Cross River Rail project

Coordinator-General's change report – whole of project refinements 2019

June 2019

Figure 3.1 Changes to the tunnel alignment

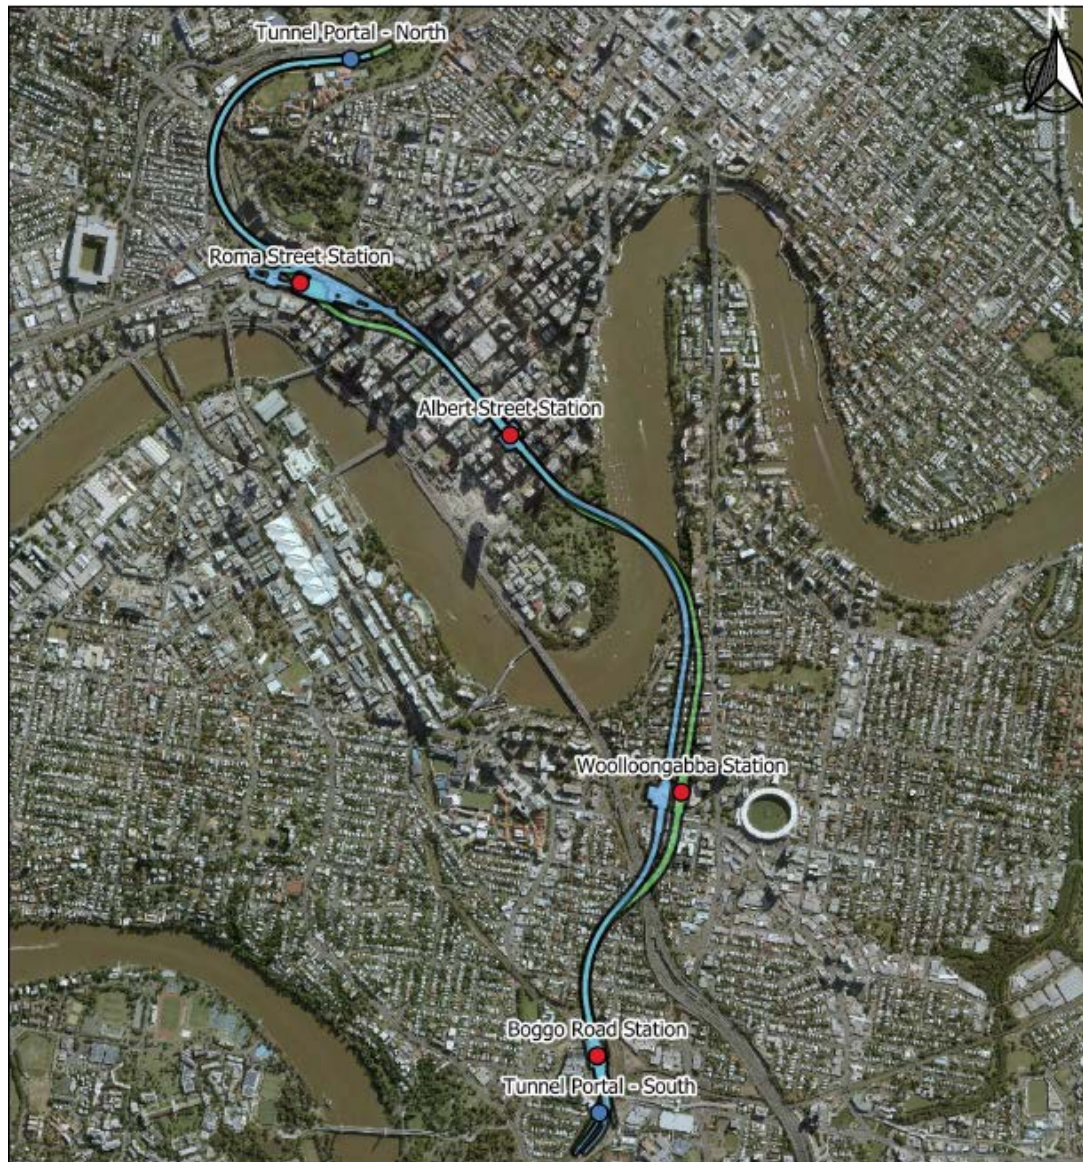
- changes to the vertical and horizontal alignments of the tunnels and relocation of the stations to reduce curvature, resulting in a change to the volumetric property impacts of the project (see Figure 3.1)

The straightening of the tunnel alignment from Woolloongabba station to Albert Street station results in the tunnel alignment under the Botanic Gardens moving slightly to the east before tying back into the previously proposed alignment at Albert Street. The vertical alignment in this area has also been deepened to increase rock cover under the Brisbane River.

Figure 3.2 Changed Woolloongabba station location

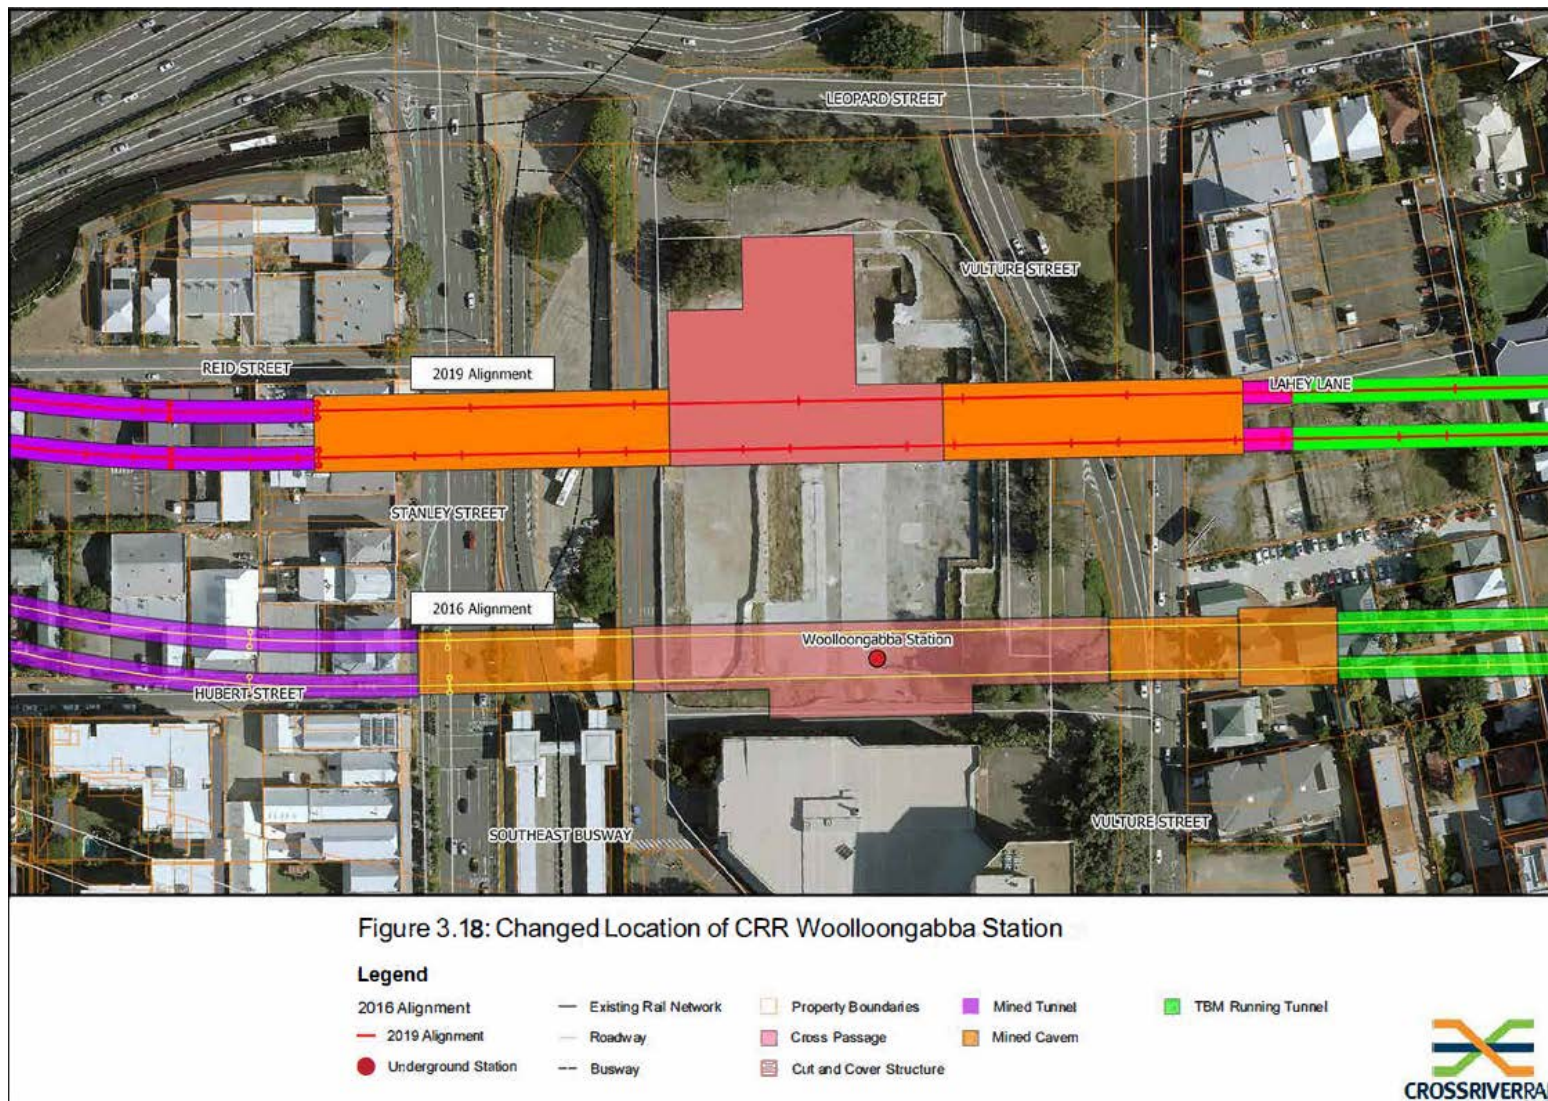
This proposed change to the station entrance will provide more space for the shared public areas, support pedestrian management of event crowds, facilitate connectivity with the Woolloongabba precinct, improve integration with the Woolloongabba bus station and will accommodate the Brisbane Metro project at Woolloongabba. The plaza connection across the existing busway has been reconfigured, with a new pedestrian access bridge between Woolloongabba station and Stanley Street over the busway. Construction methodology remains consistent with the project.

Entry to the station is now proposed to be provided within a pavilion building, rather than multiple individual entry points from an open public space. The proposed increase to station cavern size also allows for a public circulation mezzanine, which will improve flow and movement of passengers and improve pedestrian circulation in the underground station.

Figure 3.3 **Changed Albert Street station location**

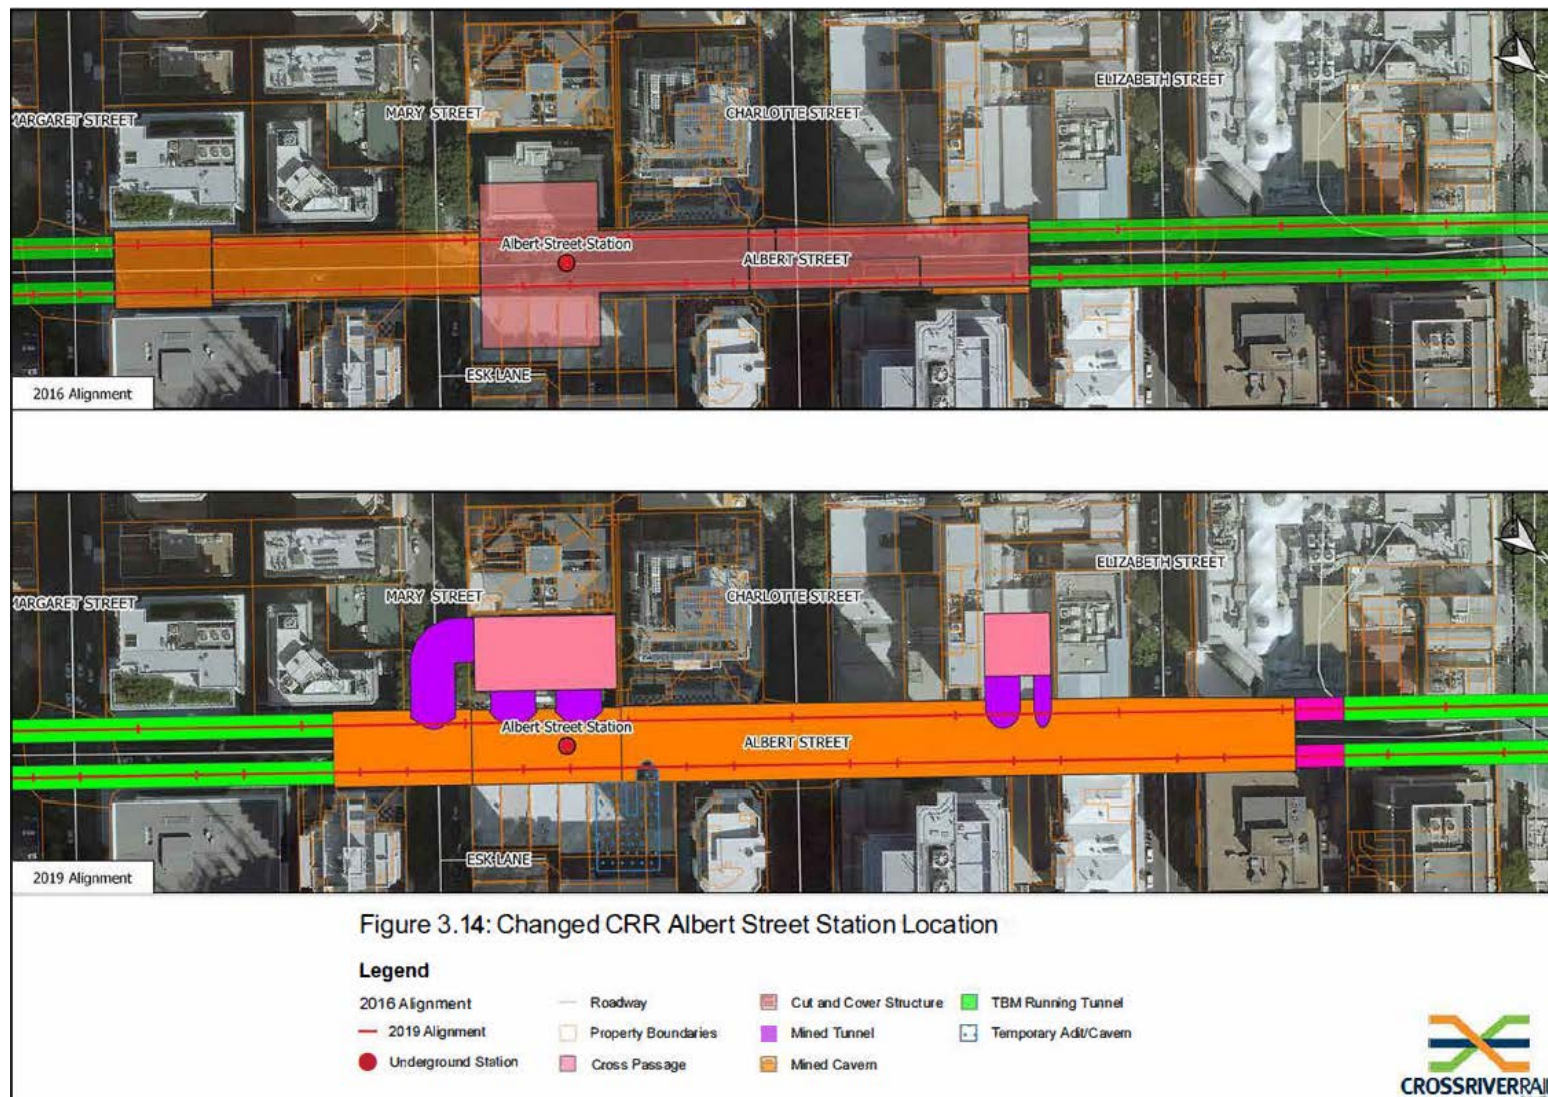
The Albert Street station is proposed to be relocated 80 m north west towards Roma Street, with the station construction methodology changing from predominantly cut and cover construction (via a central shaft with mined excavations) to a fully mined cavern as shown in Figure 3.3. The elimination of the cut and cover method at Albert Street will reduce the spoil volume to be extracted, the amount of construction work required on the surface and significantly reduce the interface with existing underground utilities.

The Albert Street station cavern will increase in size to provide a mezzanine level, with the previously proposed multiple street entrances consolidated into two plaza entrances. The southern station plaza footprint would be approximately 250m² and be contained within one lot on the south-western corner of Albert Street and Mary Street. The southern entrance to the station would be located at the junction of Albert Street and Mary Street and a new northern entrance would be located at 142 Albert Street. This will require the acquisition and demolition of the existing buildings at 142 Albert Street.

From Albert Street station the tunnel alignment will change, following Albert Street towards the existing Roma Street station, and avoiding the need to pass underneath the Brisbane Magistrates Court and the Supreme Court. These changes reduce the overall length of the tunnel, allowing 80 km/hr speeds to be maintained through the tunnel which would reduce journey time by 19 seconds in both directions.

Figure 3.4 **Changed Roma Street station location**

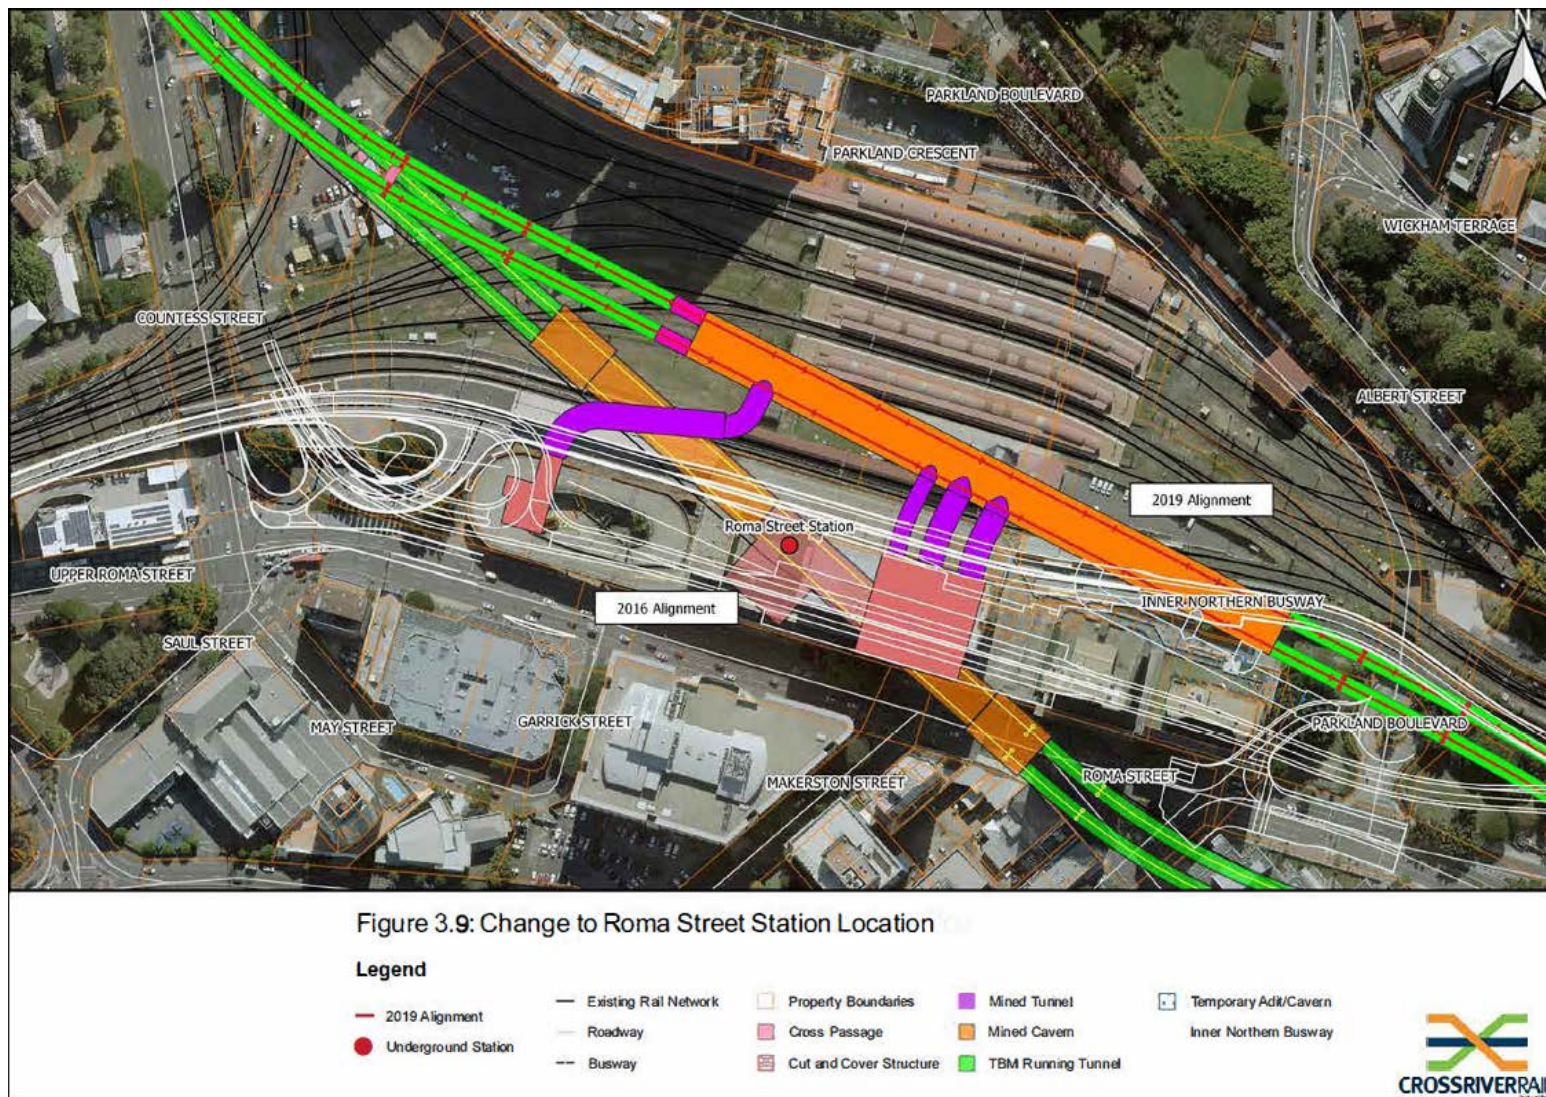
The straightening of the tunnel alignment from Albert Street results in the relocation of the proposed Roma Street station to the east compared to the project, it will now be located entirely under the existing rail yards, as shown in Figure 3.4.

The Roma Street station construction methodology will also change from a large central cut-and-cover cavern with extended mined caverns to a predominantly mined cavern, supported from two deep cut-and-cover shafts. This will relocate major construction works underground, allowing for 24/7 works (subject to compliance with the Imposed Conditions) and allow for the demolition of the Brisbane Transit Centre (BTC) and Hotel Jen to occur simultaneously with station construction activities. A temporary construction access shaft will also allow road header excavations to start prior to the demolition of the BTC and Hotel Jen.

Figure 3.5 Mayne Yard north proposed changes and new Breakfast Creek bridge

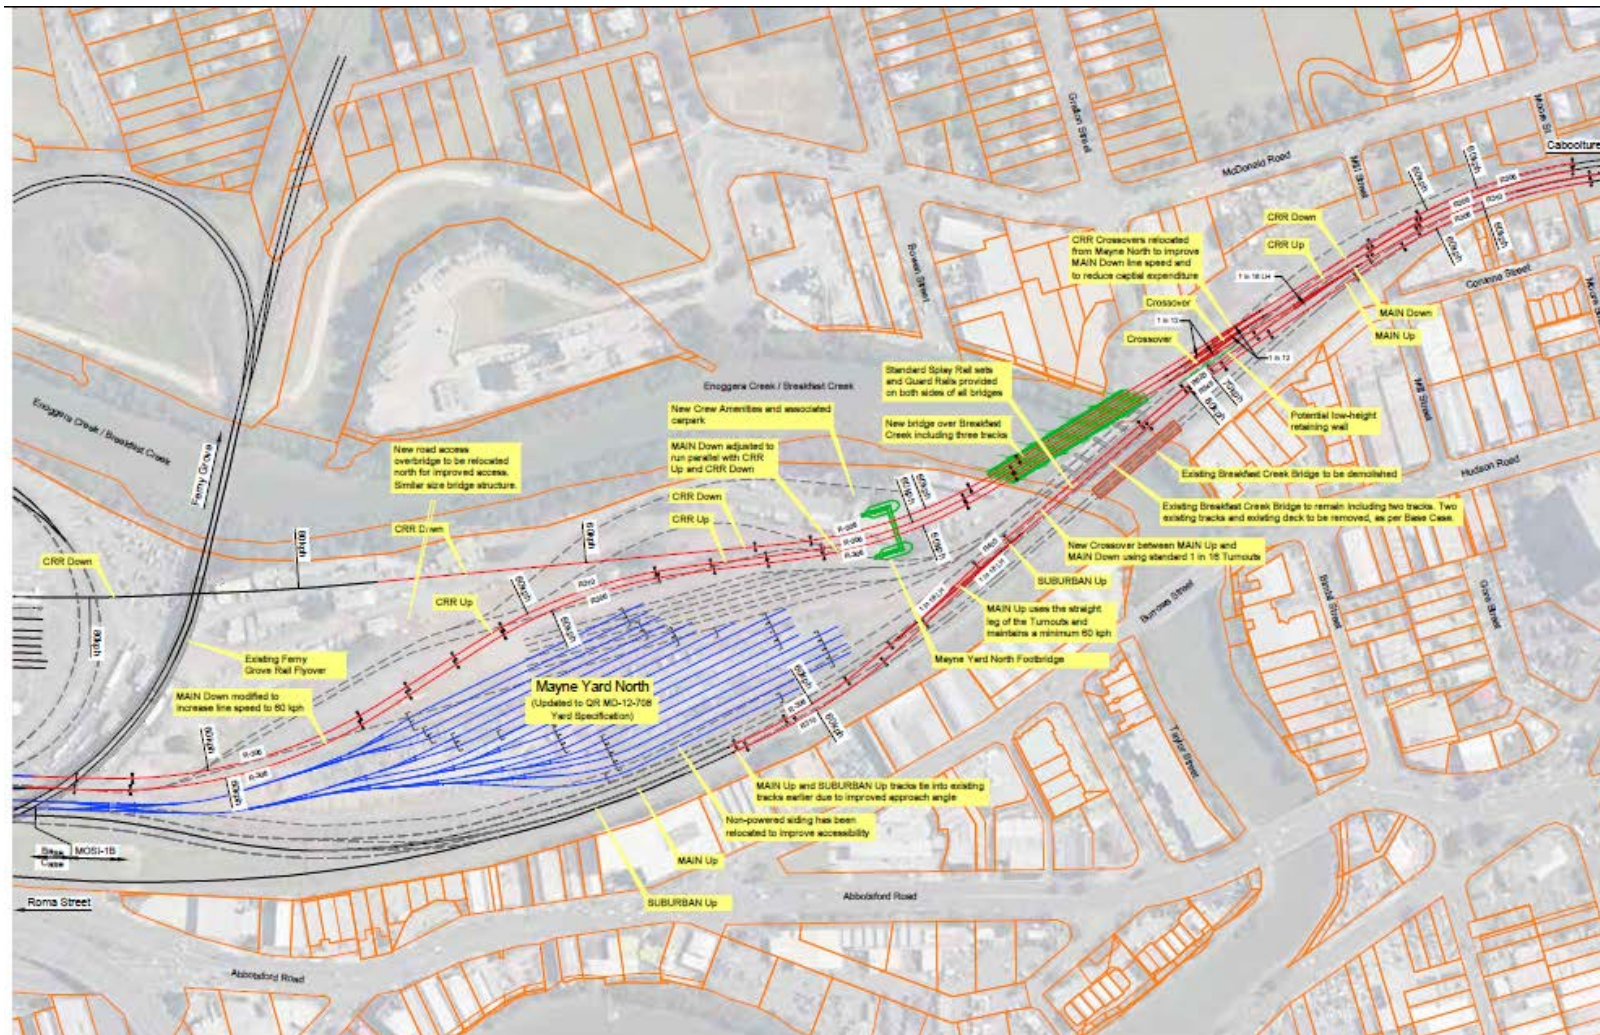
The proposed changes also include additional track work north of Breakfast Creek, with realignment of the previously proposed Cross River Rail line and crossovers within Mayne Yard. New overpass bridges for the Mayne Yard east and Mayne Yard north access roads would also be constructed. The previously proposed underpass (trough structure) has been removed.

A new rail bridge is proposed to be constructed over Breakfast Creek, with construction works to include piling and installation of the bridge (50 m west of the existing crossing) and dredging of approximately 3,000 m³ of material to enlarge the creek and minimise flooding impacts. The existing eastern two track rail bridge (suburban line bridge) will be demolished. The proposed additional surface works at Mayne Yard will all be undertaken within the existing rail corridor.
